ORIGINATION FORM

Proposed Revisions to a Standard Plans Index (Please provide all information — Incomplete forms will be returned)

Index Number: 521-660

Index Title: Light Pole Pedestal - Bridge

CONVENTIONAL REINFORCING STEEL BENDING DIAGRAMS

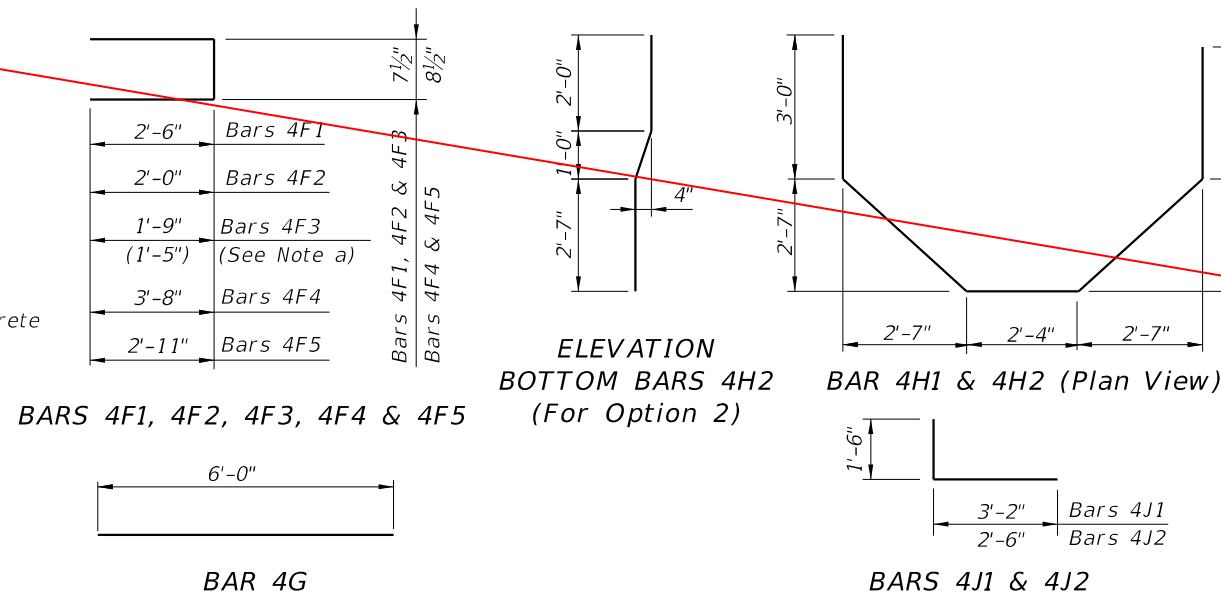
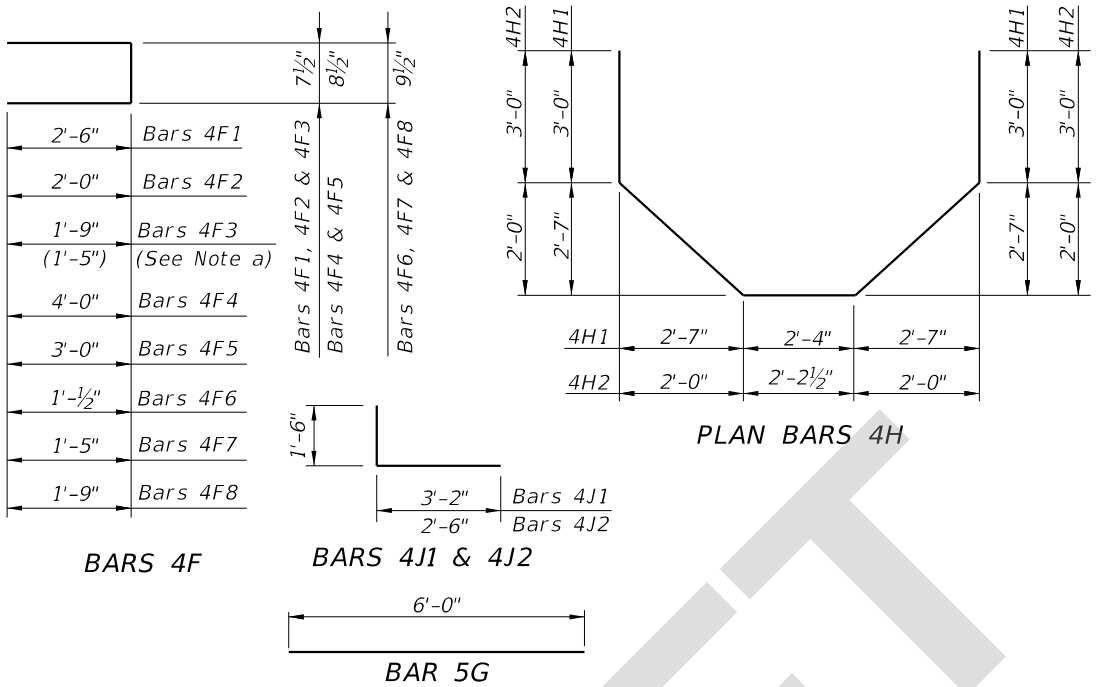
Reworked bar list to fit in new option

MARK	SIZE	NO. REQD.	LENGTH	NOTES
F1	4	16	5'-8"	c
F2	4	4	4'-8"	c
F3	4	4	4'-2" (3'-6")	a, c
F4	4	8 (6) [4 for Option 3]	8'-9"	b, c
F5	4	4	6'-9"	c
F6	4	4	2'-11"	-
F7	4	4	3'-8"	-
F8	4	12	4'-4"	-
G	4	8 [5 for Option 3]	6'-0"	-
H1	4	2	15'-8"	-
H2	4	2	13'-10"	-
J1	4	8	4'-8"	d
J2	4	12	4'-0"	d

DETAIL "A"

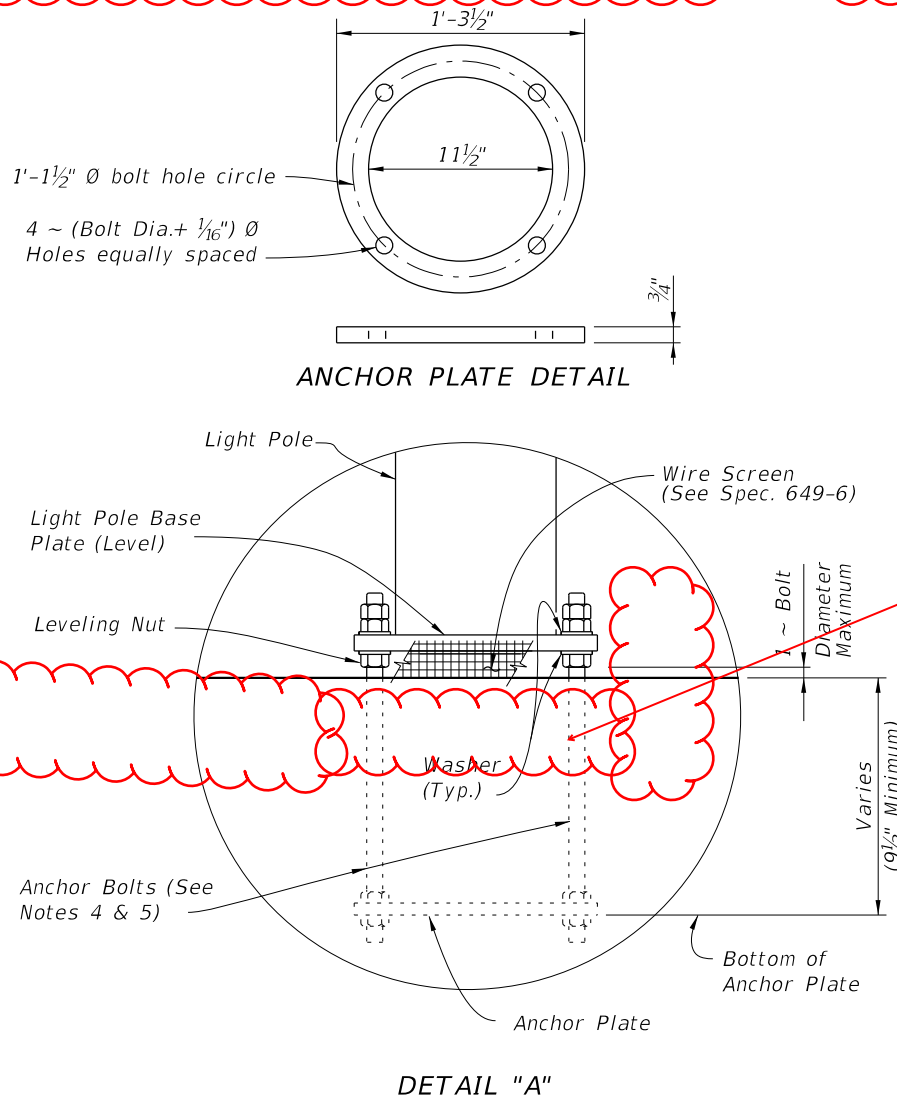
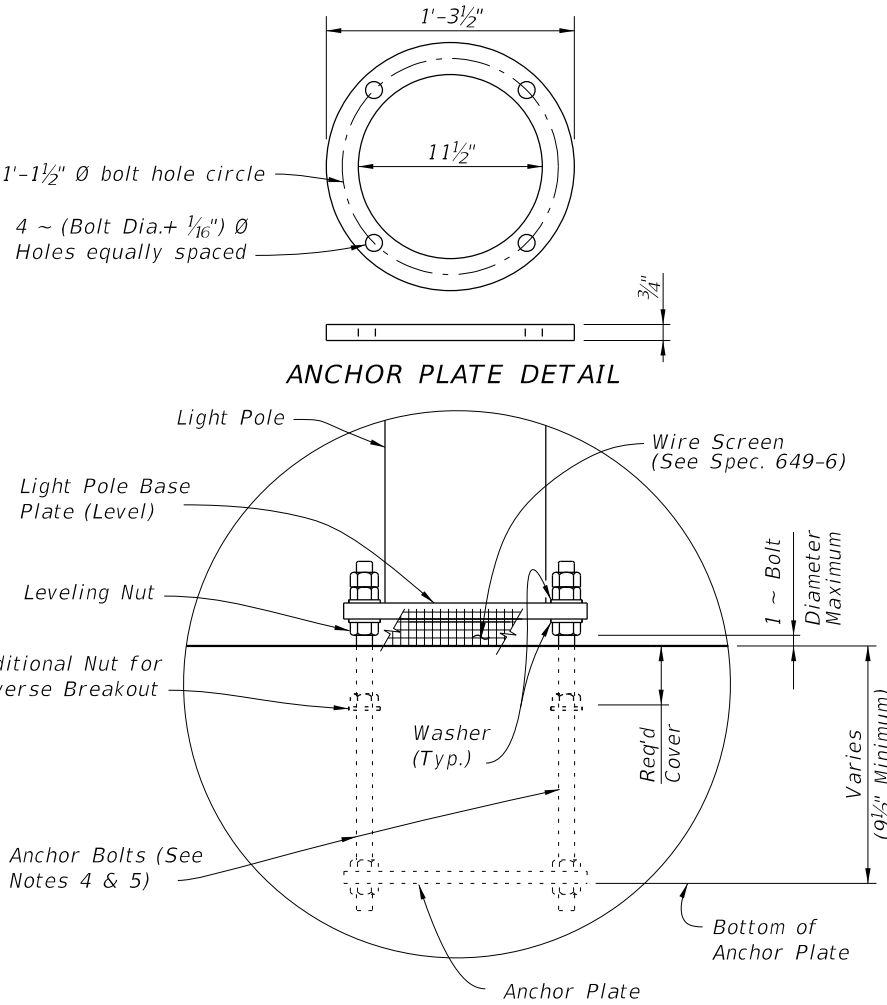
Added anchor nut for bottom of pedestal anchor breakout

OPTION 3 - PLAN VIEW
WITH GAP BETWEEN BARRIER AND PEDESTAL TO ALLOW SLIP FORMING

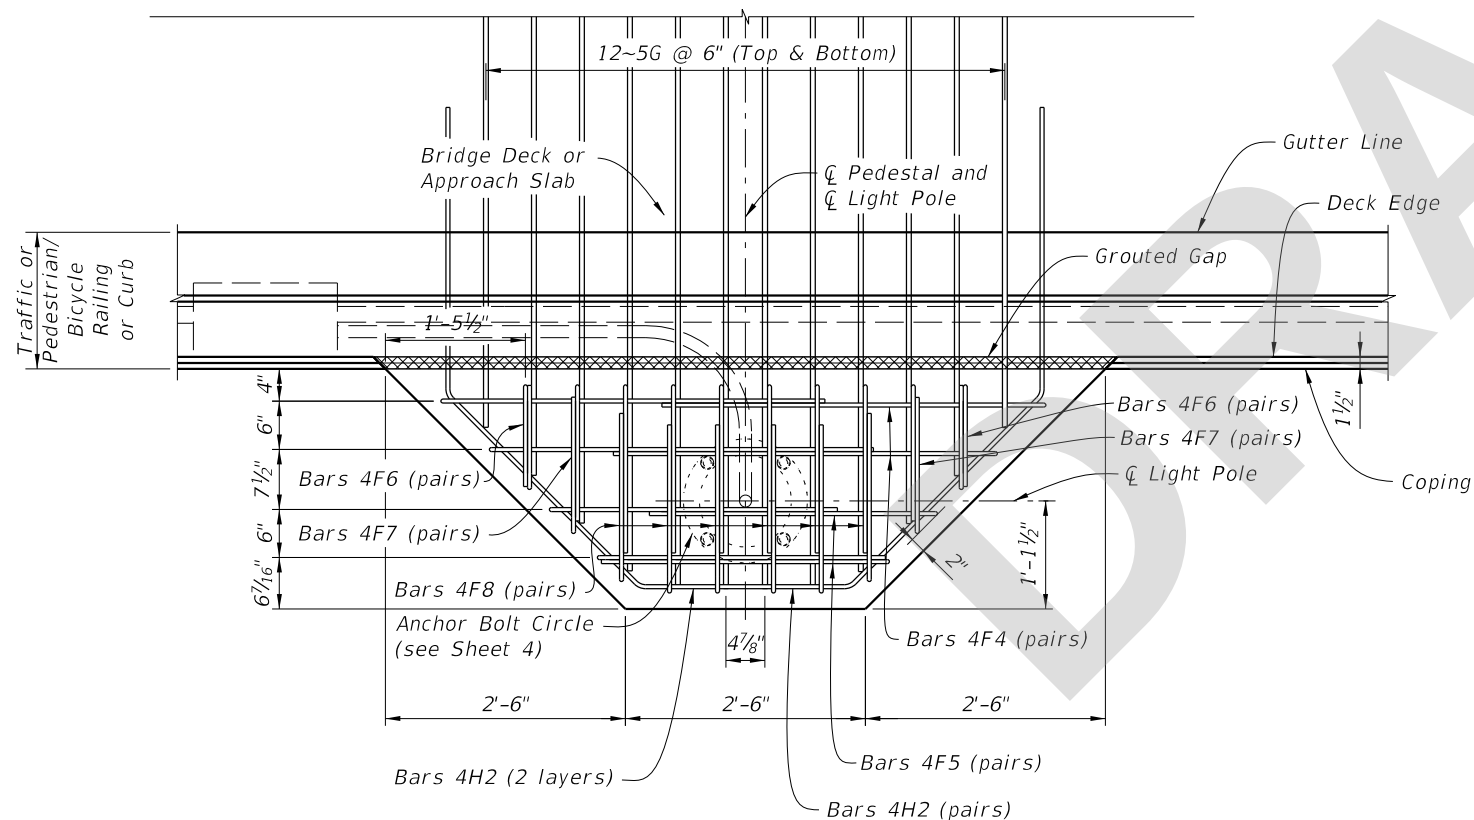
An option was included to allow for slip forming of the traffic barrier at the pedestal location. A gap was included between the barrier and pedestal to facilitate this.

Contractor request in order to save time and materials required to form barrier separately at light pedestal locations.
